**SERVICE BULLETIN NO. 224 - PIPER**

**SERVICE BULLETIN** *No. 224*

SUBJECT: Mitchell Bulletin No. A55 -- Modification of Pitch Servo

SUPPLEMENT TO SERVICE BULLETIN NO. 224

VIEW LOOKING DOWN THROUGH FLOORBOARD  
ON PILOT'S SIDE

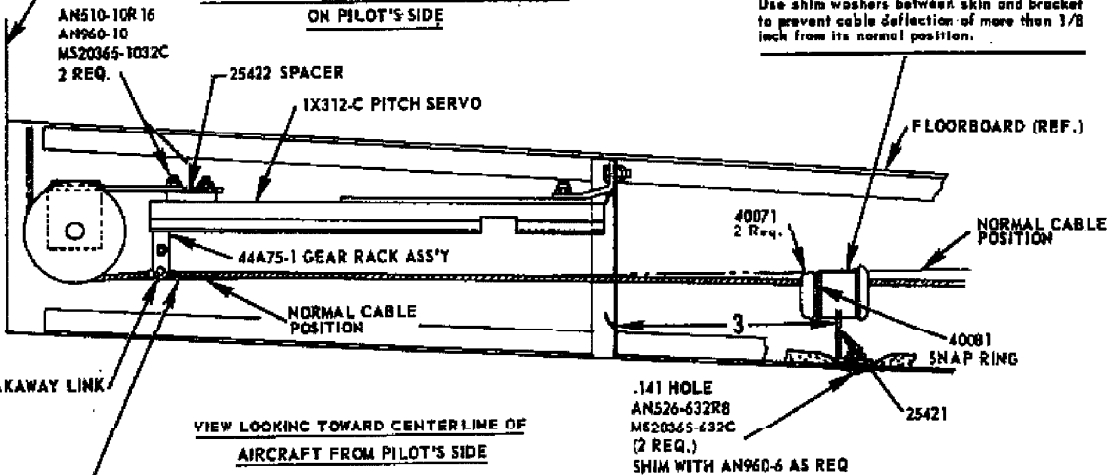
1. See Piper Electronic News Letter No. EL-48 for lubrication instructions
2. See sketch below for details and installation of fairlead which is a part of this modification

Install this bracket so the upper portion of the fairlead contacts the top of the cable. Use shim washers between skin and bracket to prevent cable deflection of more than 1/8 inch from its normal position.

Cable must have upward deflection of 1/16" thru full travel of rack assy.
